Access Compliance Report

Public Rights-of-Way

(Curb Ramps)

Intersection ID: 50619	Main Street: COTTON_GUM_RD	Cross Street: YELLOW_OAK_RD	Location: SE
ADA ID: C70667D39ADA	Ramp Type: Perp	Initial Pass/Fail: Fail	Overall Compliance: No
Severity Score: 12.5			
Codes/Mitigation Info/Possible Solution		Field Measurements/Component Compliance

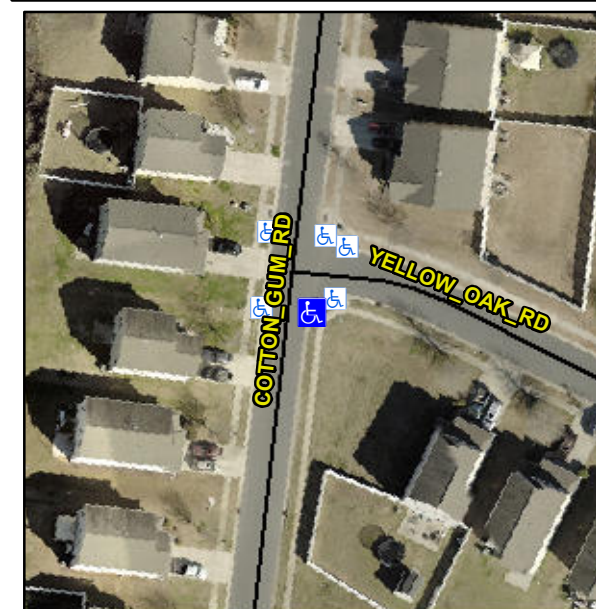
Not Found, R304.2.2

Compliance	Description	Data	Compliance	Description	Data
N/A	Ramp Length (in)	47.0	No	Ramp Slope (%)	9.0
Yes	Ramp Width (in)	48.0	Yes	Ramp XSlope (%)	1.1
N/A	Flare Type LT	N/A	N/A	Flare Type RT	N/A
N/A	Flare Slope LT (%)	N/A	N/A	Flare Slope RT (%)	N/A
N/A	Flare Traversable LT?	N/A	N/A	Flare Traversable RT?	N/A
N/A	Landing Length (in)	N/A	N/A	DWS Provided?	N/A
N/A	Landing Width (in)	N/A	N/A	DWS Contrast?	N/A
N/A	Landing Slope (%)	N/A	N/A	DWS Length (in)	N/A
N/A	Landing X Slope (%)	N/A	N/A	DWS Full Width?	N/A
N/A	Landing Curb? (Y/N)	N/A	N/A	DWS Offset (in)	N/A
N/A	Shared Landing?	N/A			
N/A	Gutter Ponding?	N/A	N/A	Gutter Slope (%)	N/A
N/A	Gutter Lip Ht (in)	N/A	N/A	Gutter X Slope (%)	N/A
N/A	Painted X Walk1?	No	N/A	Painted X Walk2?	N/A
	X Walk 1 Direction	To W		X Walk 2 Direction	N/A
N/A	X Walk 1 Width (in)	N/A	N/A	X Walk 2 Width (in)	N/A
	X Walk 1 Slope (%)	2.8		X Walk 2 Slope (%)	N/A
	X Walk 1 X Slope (%)	3.2		X Walk 2 X Slope (%)	N/A

Remove & Replace Entire Ramp.
